**From:** [Unitary Plan](#)  
**To:** [Unitary Plan](#)  
**Subject:** Unitary Plan Publicly Notified Submission - Plan Change 100 (Private) - Ryan Sclanders  
**Date:** Friday, 17 May 2024 8:30:24 am  
**Attachments:** [Flooding\\_20240517081931.465.pdf](#)  
[Traffic.pdf](#)

Plan change number: Plan Change 100 (Private)

Plan change name: PC 100 (Private): Riverhead

FIGURE 1: RIVERHEAD CORE RETAIL CATCHMENT

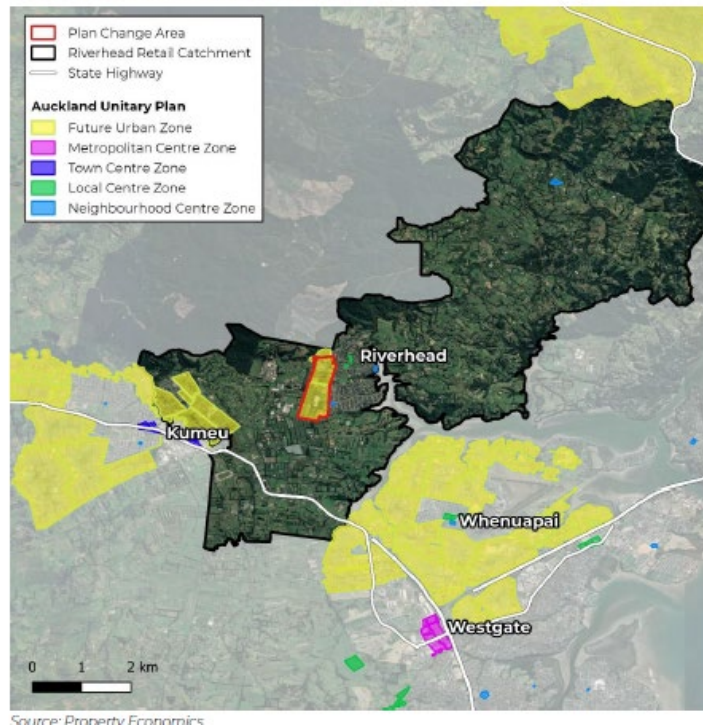
17. Defining this as a catchment for Riverhead as a retail destination is ridiculous at both extents of the area shown. People in the Kumeu area have no incentive to travel to Riverhead for shopping. Kumeu is well served with a supermarket and a huge range of retail and commercial services. Council’s own consultation documents for Kumeu show the extensive land at Kumeu dedicated for these activities.

FIGURE 1: RIVERHEAD CORE RETAIL CATCHMENT

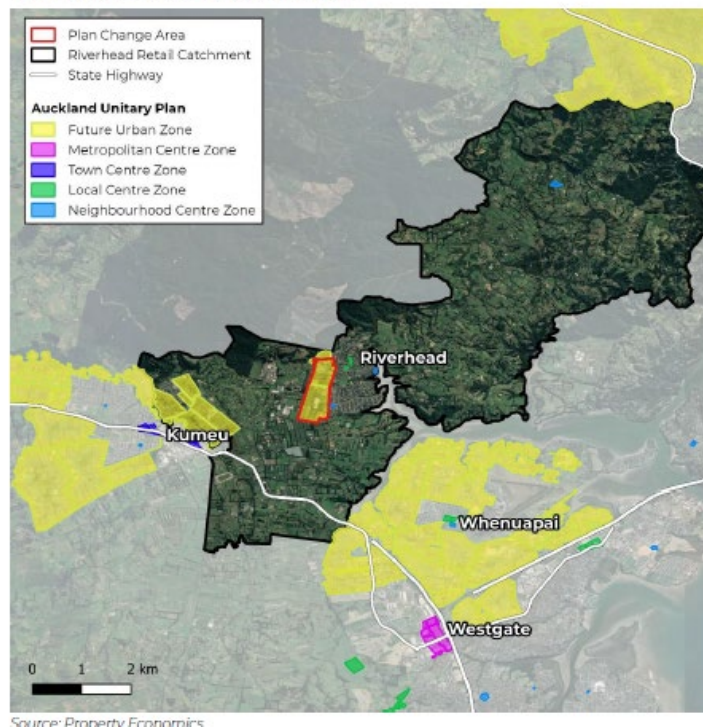
17. Defining this as a catchment for Riverhead as a retail destination is ridiculous at both extents of the area shown. People in the Kumeu area have no incentive to travel to Riverhead for shopping. Kumeu is well served with a supermarket and a huge range of retail and commercial services. Council’s own consultation documents for Kumeu show the extensive land at Kumeu dedicated for these activities.

**Figure 8-2: Indicative future Coatesville Riverhead Highway corridor design between SH16 and Short Road (adjoining eastern boundary)**

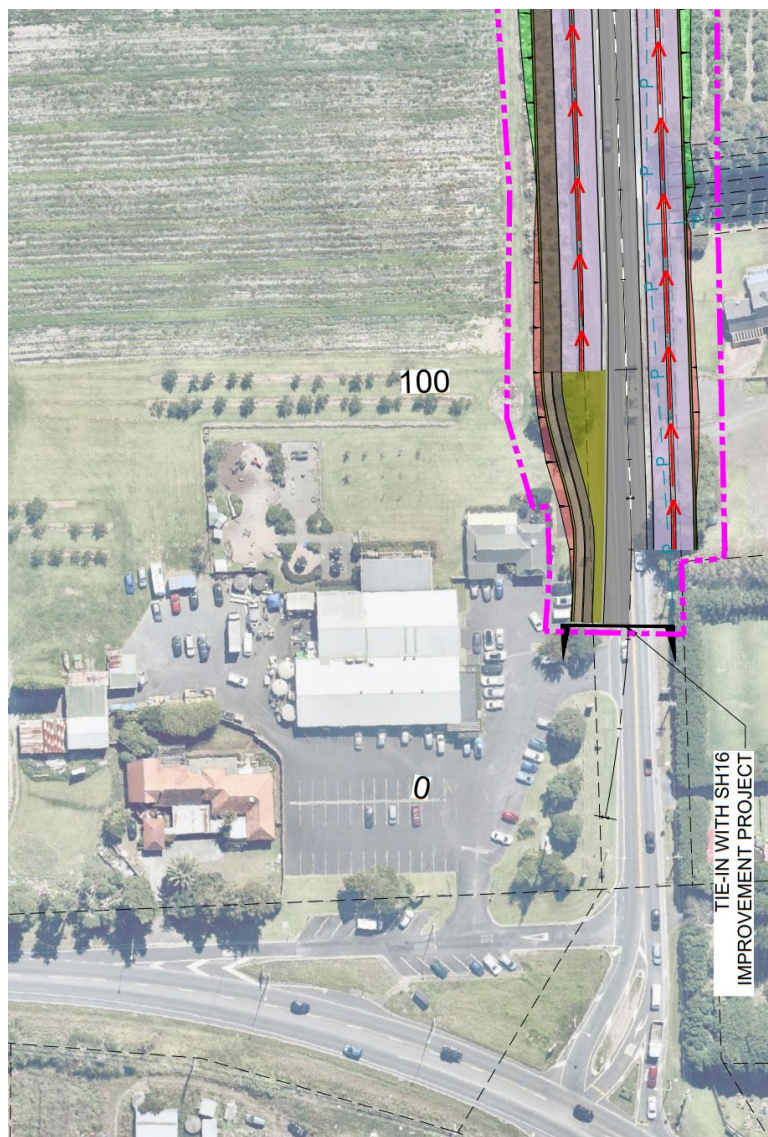
- Firstly, the southern end of the land to which this NoR relates culminates on the northern edge of the existing vehicle crossing to the Boric Food Market. The southern end will tie into the future roundabout at SH16 as part of the Waka Kotahi SH16 Safety Improvements Project, which is understood to be the subject of a separate (yet to be notified) application. Without understanding how both NoR applications will tie in together, it is difficult to understand and assess the potential effects the proposal will have on the existing access arrangement, being the main vehicle access to the commercial activity on the site. In particular, the potential

impacts from the proposed active mode path on the western side of the Highway on the access are unclear.

6. At its southern end, the proposed boundary of the NoR (pink dashed line) appears excessively wide relative to the proposed extent of works within the corridor, resulting in the loss of at-grade parking at the eastern boundary of the Boric Food Market and require the site’s western boundary to be relocated immediately adjacent to an existing building on the site – further separation is required in order to maintain the existing building.

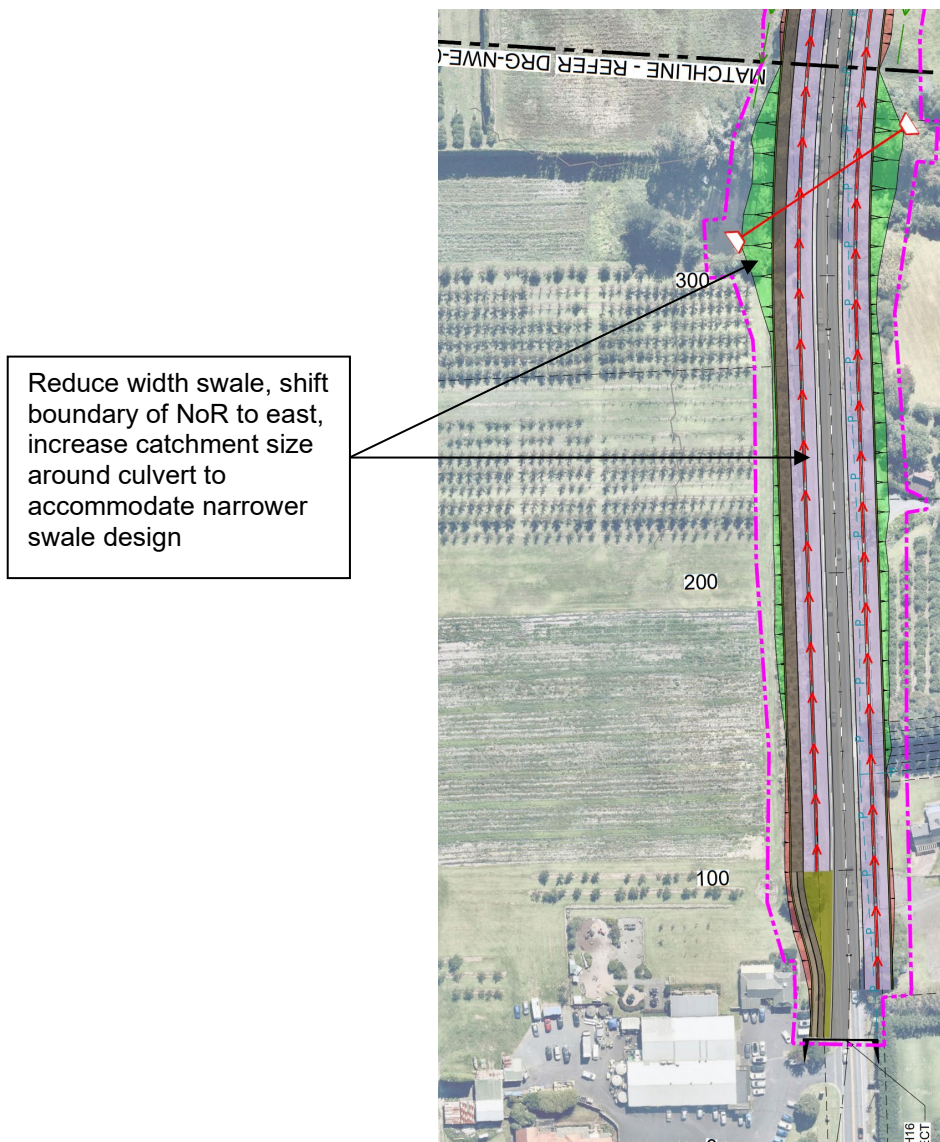
7. The width of the NoR boundary appears overly wide relative to the extent of proposed works along the full length of the corridor between SH16 and Short Road. The swale shown in purple appears overly wide, contributing to the width of the

designation overall. It is suggested instead to narrow its width and rather increase the area of land that is proposed to be taken around the existing stormwater pond adjacent the culvert (illustrated below). This approach will coincidentally narrow the extent of highly productive land that is required to be taken for swales, utilising land already used for stormwater purposes.
